REPORT
THIRD PARTY AUDITING OF RAILWAY BRIDGES (PHASE I)

(Job No: CED/CON/TMMP/SAS/2019312)

**Br. No. 136 (1×6.1 m) Stone arch bridge at km. 45/700-800 between
Melattur & Tuvvur Stations**

SOUTHERN RAILWAY PALGHAT DIVISION

Figure 6. Vegetation growth above the crown

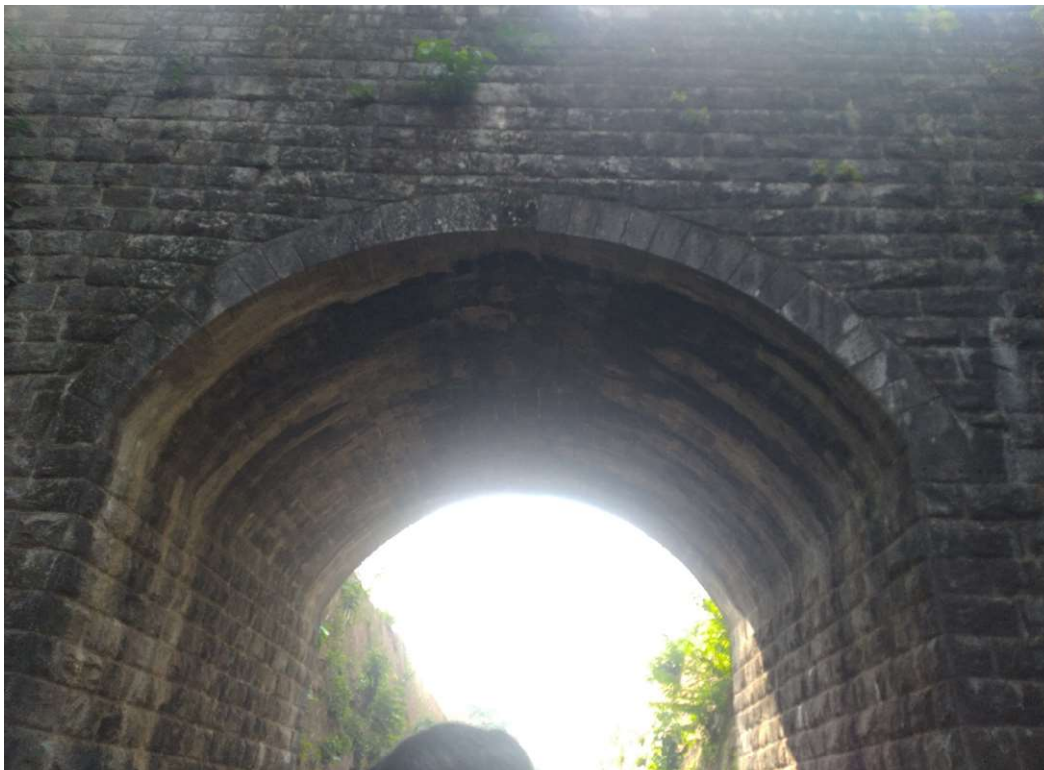
The geometry of the bridge is obtained by taking measurements in the field. Fig.4 shows the details of geometry and various elements. Based on a careful examination of the bridge, the observations are tabulated in the following Table 1. The Table shows various elements of the bridge, defect type, follow up actions required and remarks. Labels are assigned to various types of defects as given in Table 2. Vegetation growth is seen on the masonry work and in backfill as shown in Figs.5 and 6.

Table 3 shows that arch bridge has sufficient reserved capacity against gravity loading and vehicle loading, thus it is found to be safe. The bridge is assessed to be stable also based on the visual inspection. In view of these the bridge is deemed to be **safe and stable**. It is suggested to monitor the bridge and the abutment on a regular basis and clean the unwanted vegetation growth which if neglected may lead to soil erosion and subsequent distress to the bridge.

Figure 8. axial stress distribution along the span of arch

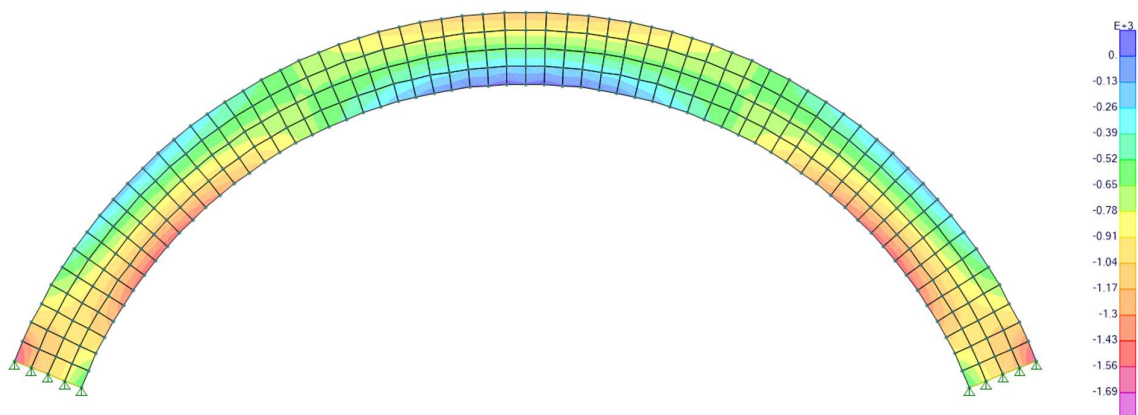
Axial compressive stress in the arch ring = 1.72 MPa < 2.5 Mpa
